Machine	TASKI swingo XP
Subassembly	Electronic

New Firmware Version 3.41

GTS Newsletter

2012 / 32E

Example: Electronic of TASKI swingo 755 with yellow battery indication sticker.

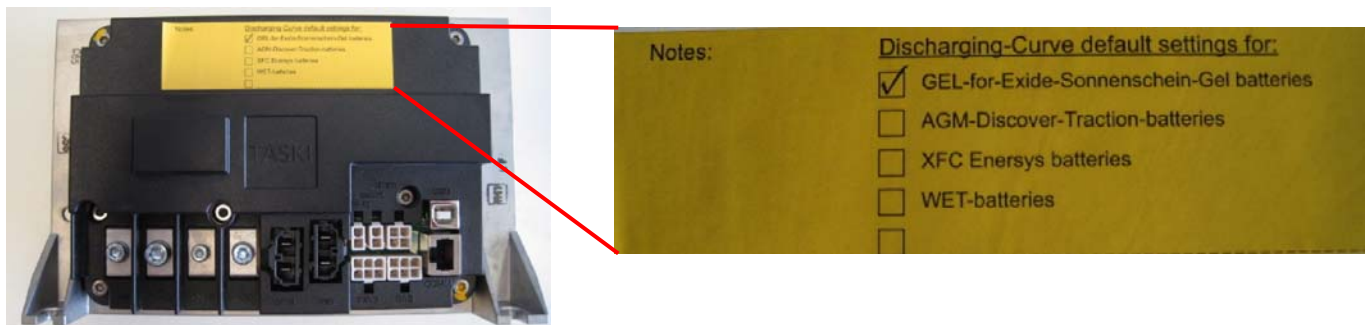
With immediate effect all electronics will be tagged with a sticker, which is describing the 4 battery types. The sticker is meant for a visible determination of the adjusted battery type in case of service updates.
